PLAN CHANGE 92 – SUMMARY OF CHANGES TO RECOMMENDATIONS BASED ON COUNCIL EVIDENCE – 6 SEPTEMBER 2023

The purpose of this document is to update the recommended changes which were published in the following documents at the time of releasing the Section 42A report:

Attachment A – Recommended Changes to District Plan Maps

Attachment B – Recommended Changes to District Plan Text

**ŌMOKOROA
NATURAL HAZARDS MAP**

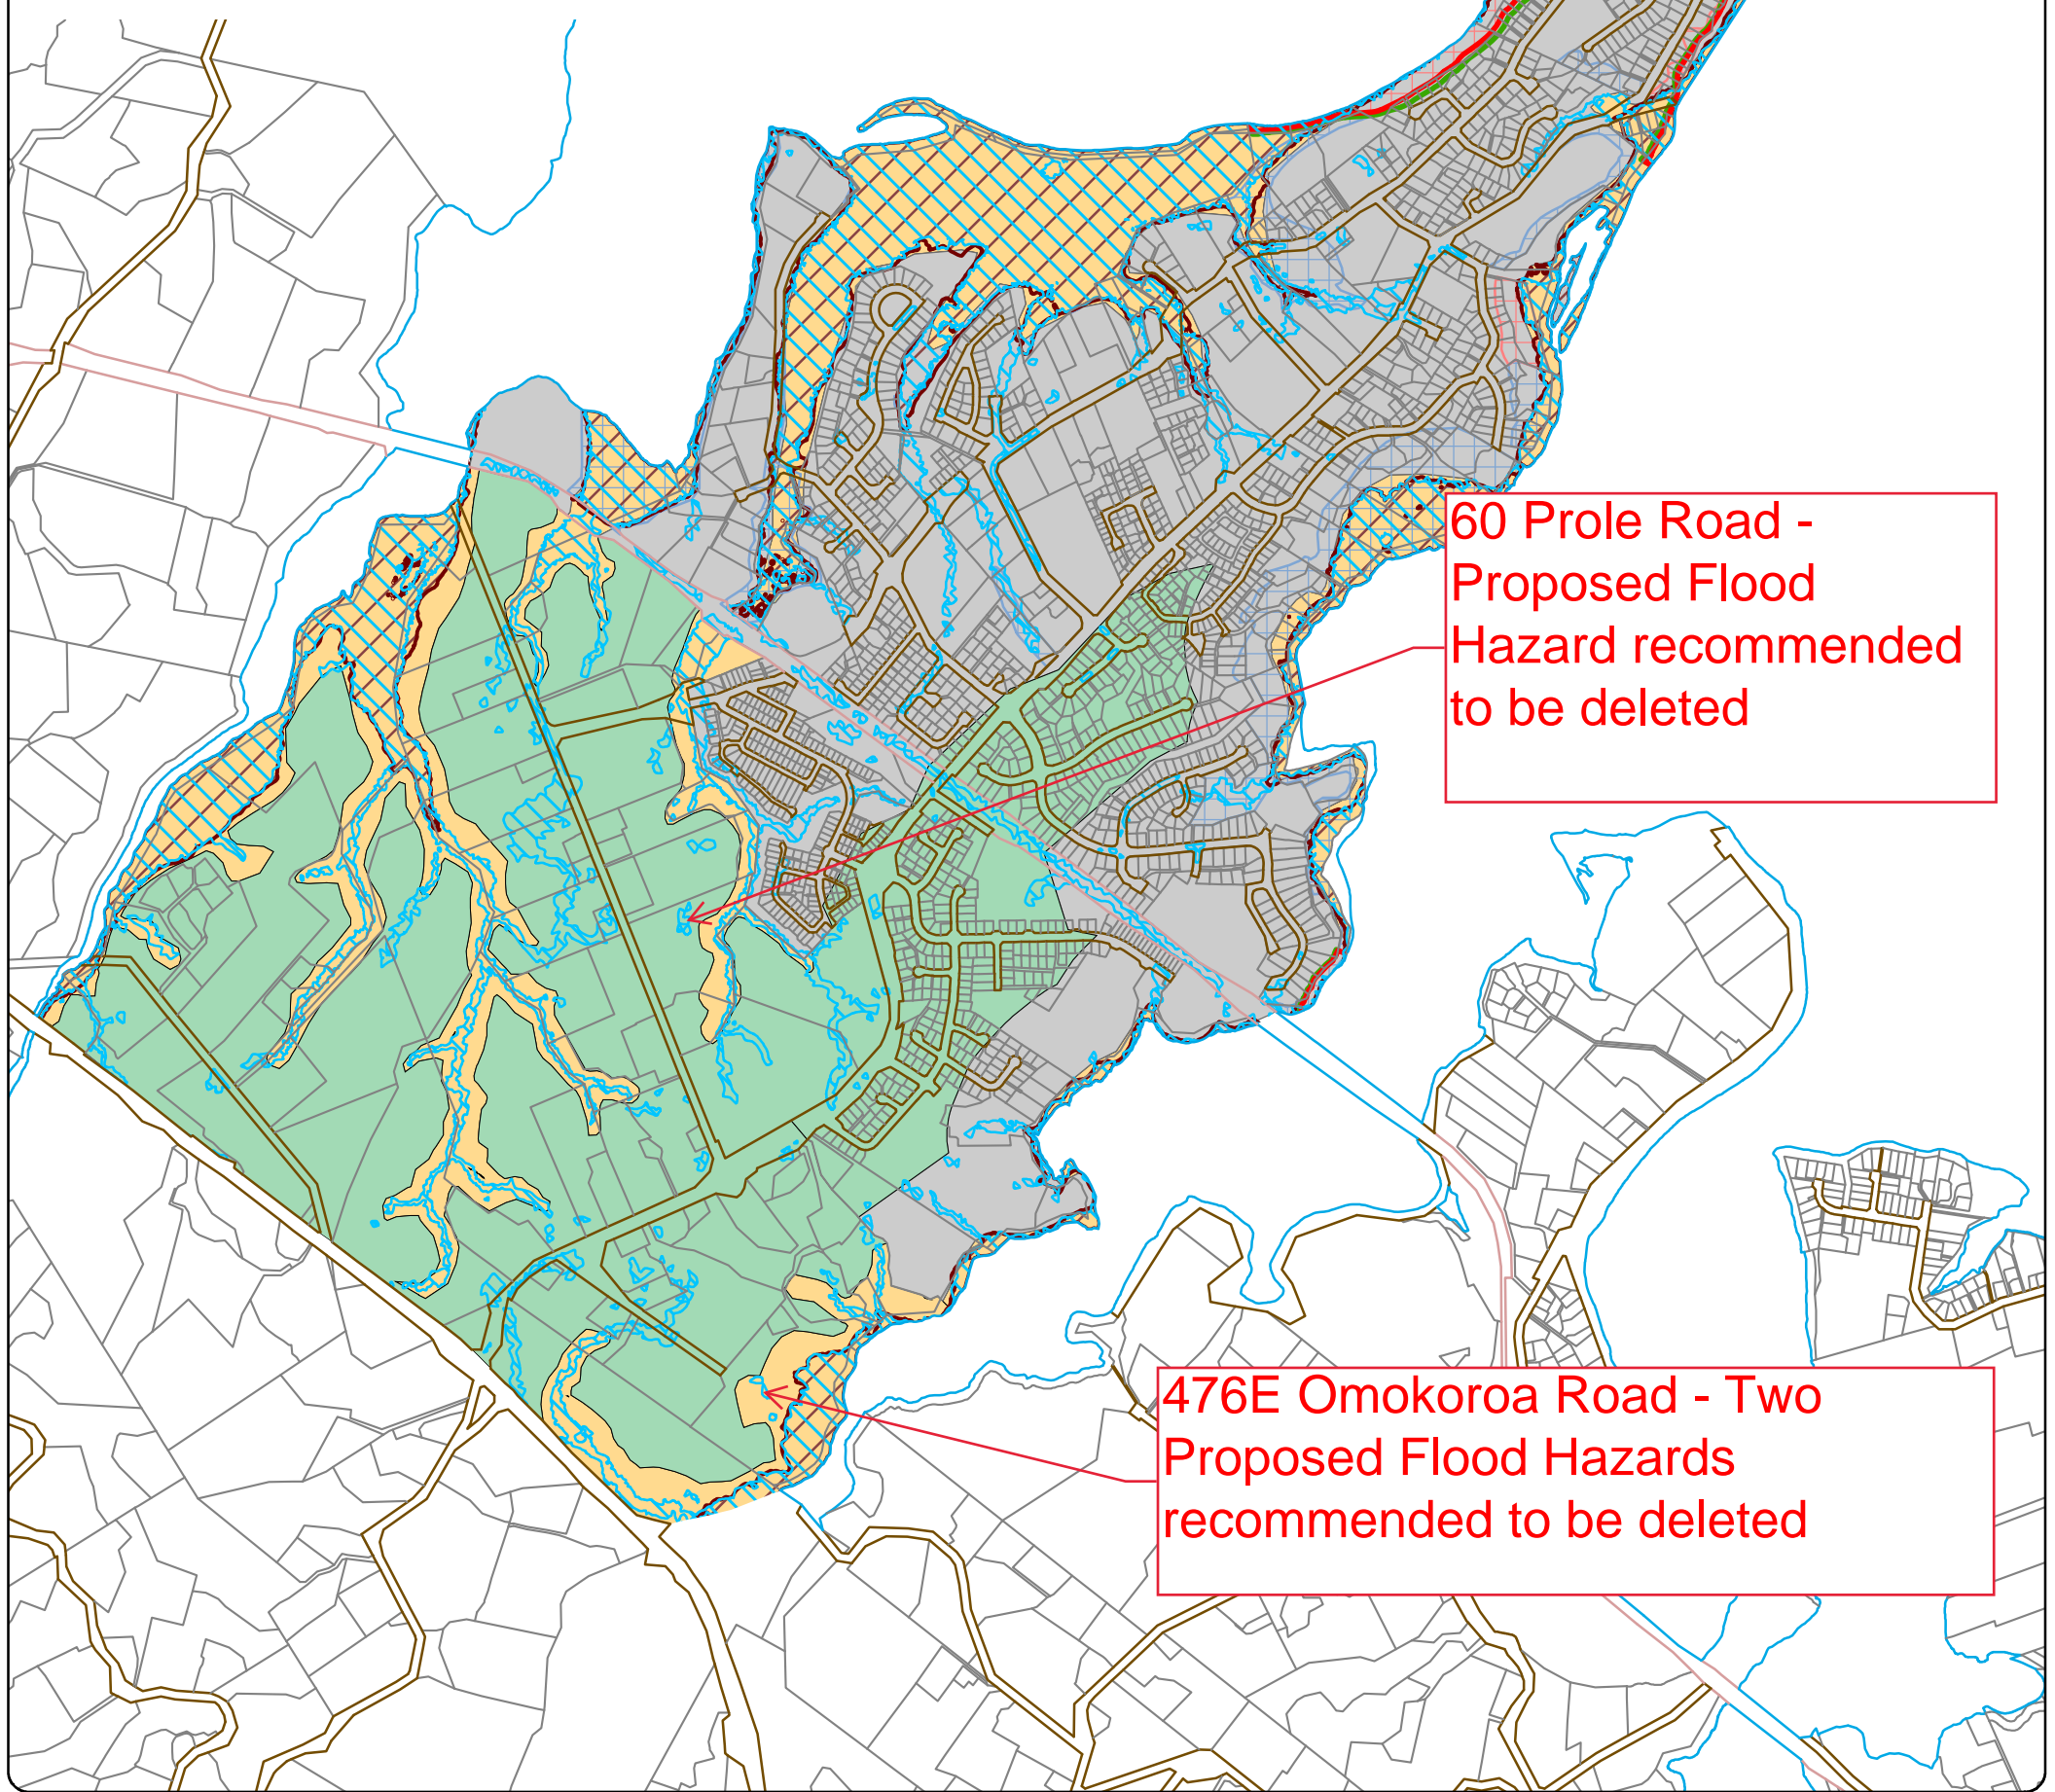
All proposed Omokoroa liquefaction maps are recommended to be deleted

60 Prole Road - Proposed Flood Hazard recommended to be deleted

476E Omokoroa Road - Two Proposed Flood Hazards recommended to be deleted

TE PUKE NATURAL HAZARDS MAP

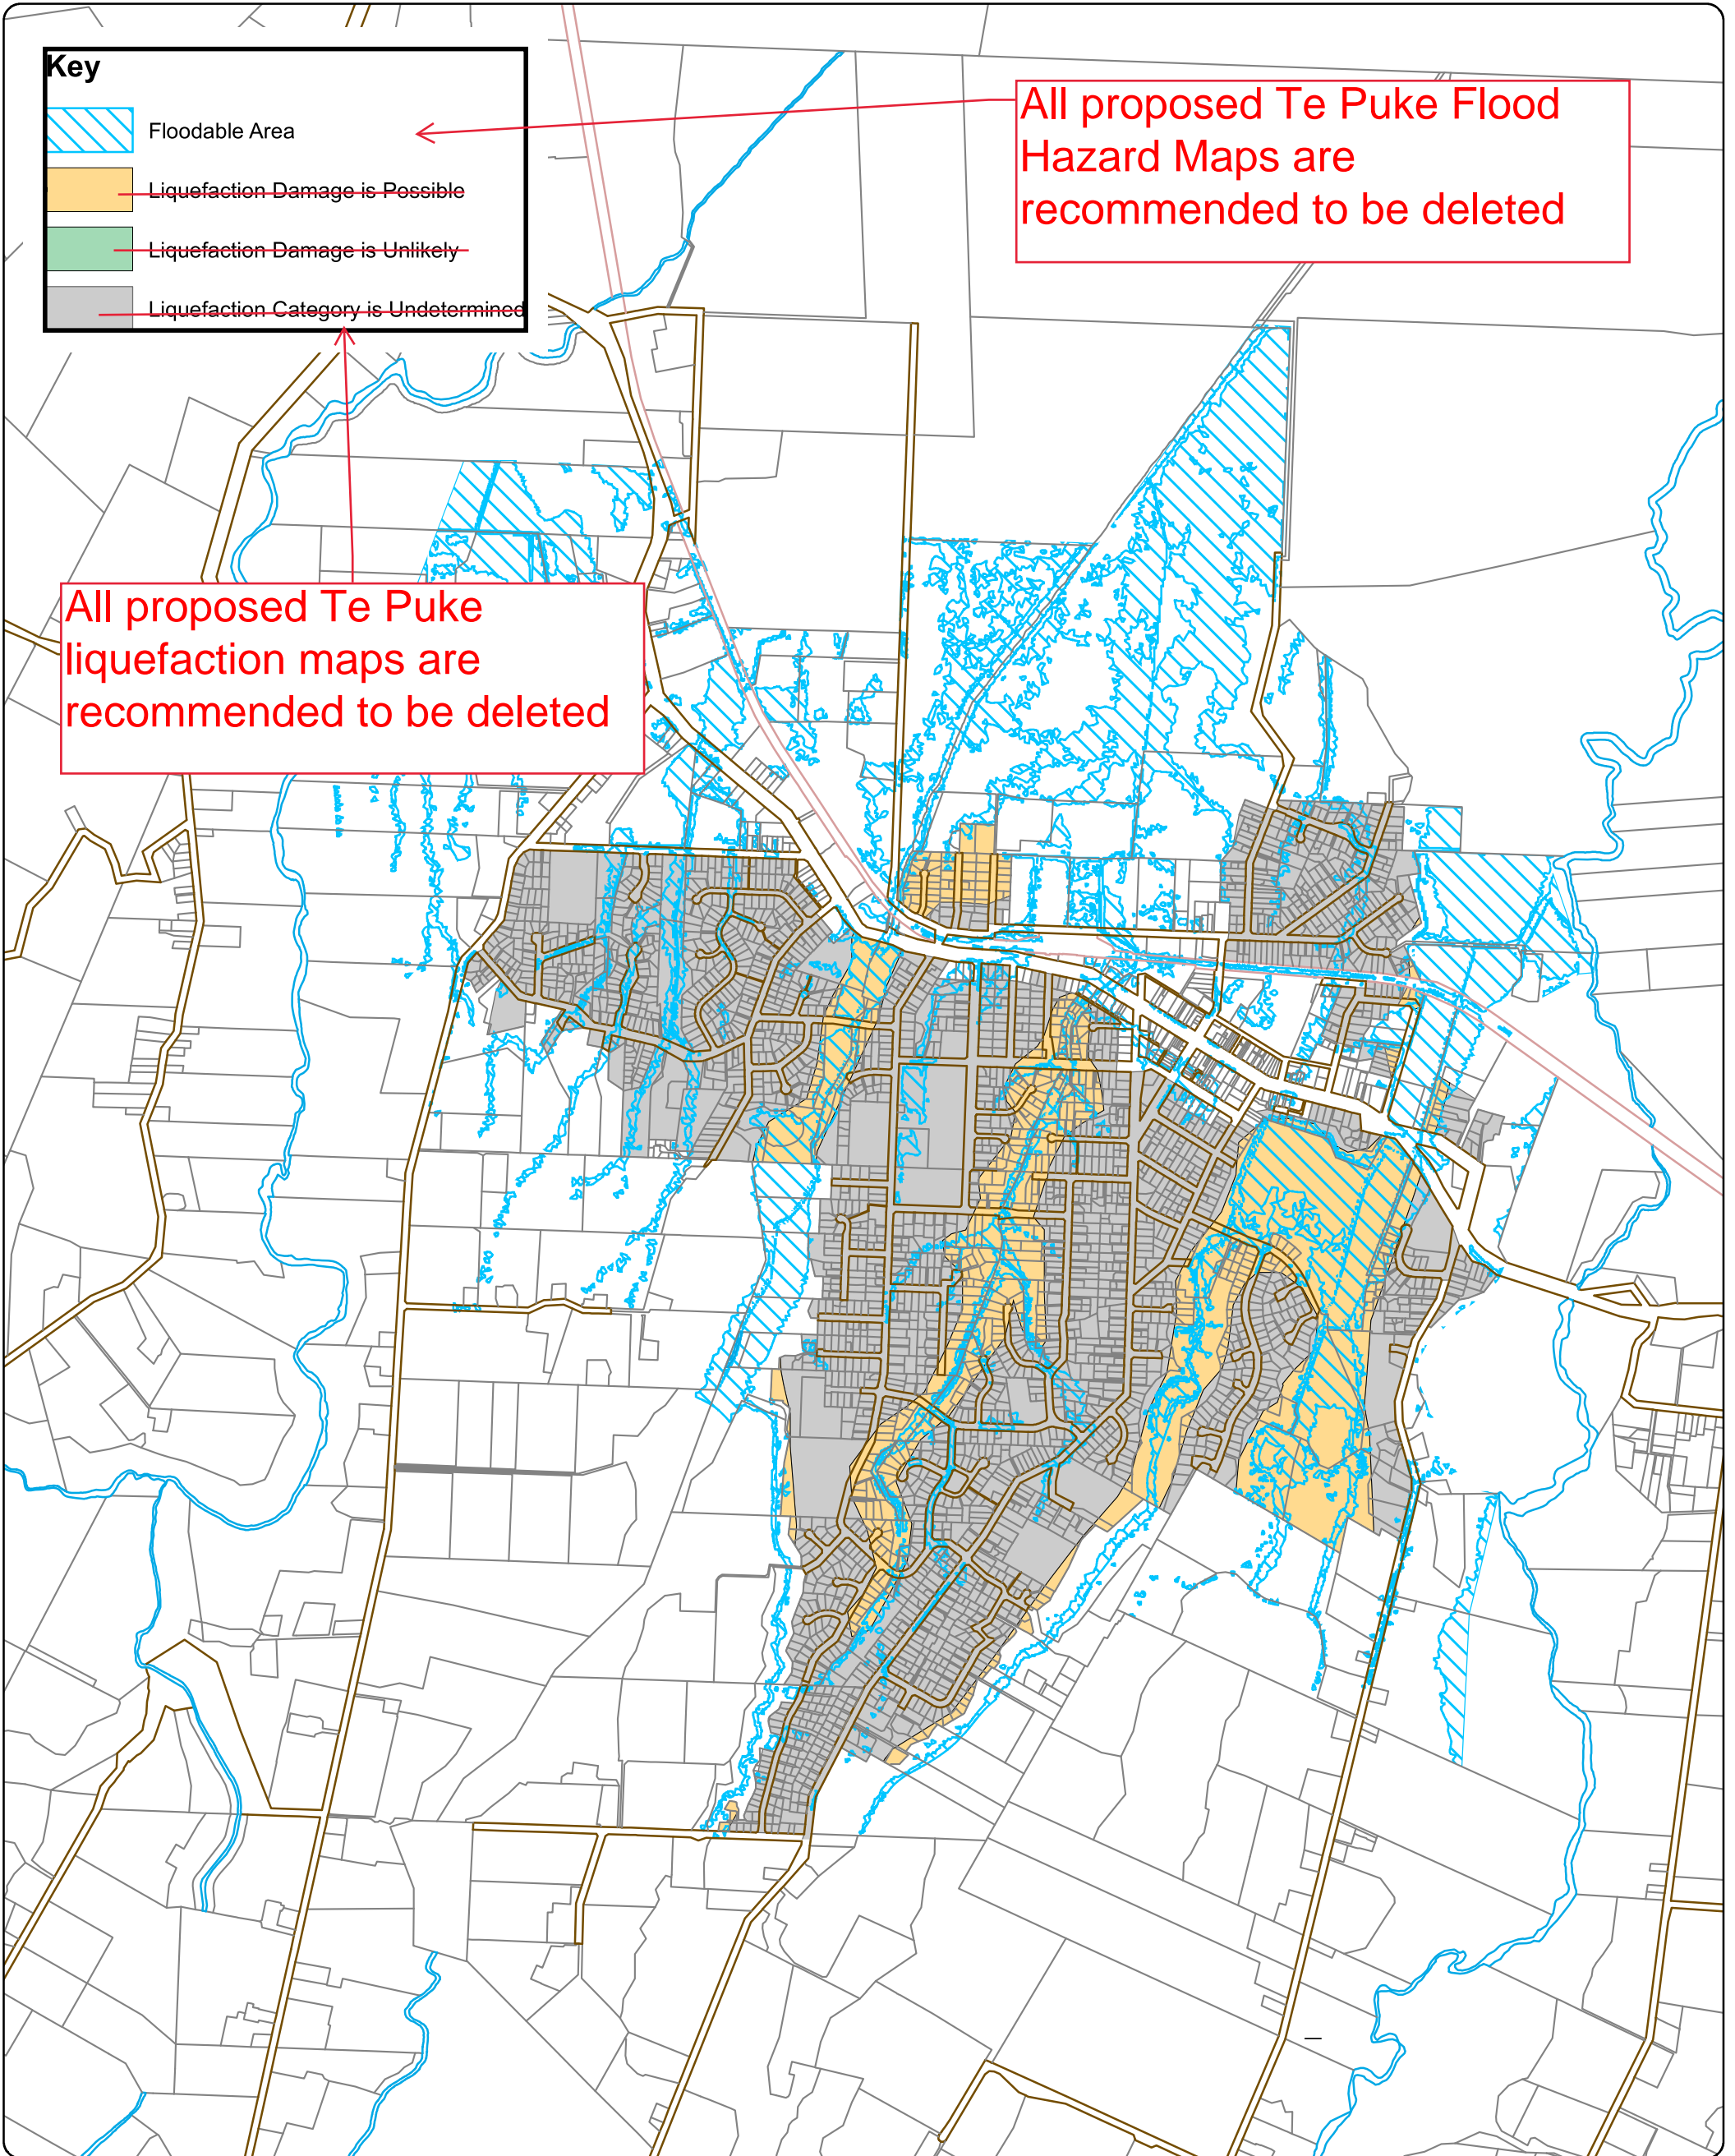
All proposed Te Puke Flood Hazard Maps are recommended to be deleted

All proposed Te Puke liquefaction maps are recommended to be deleted
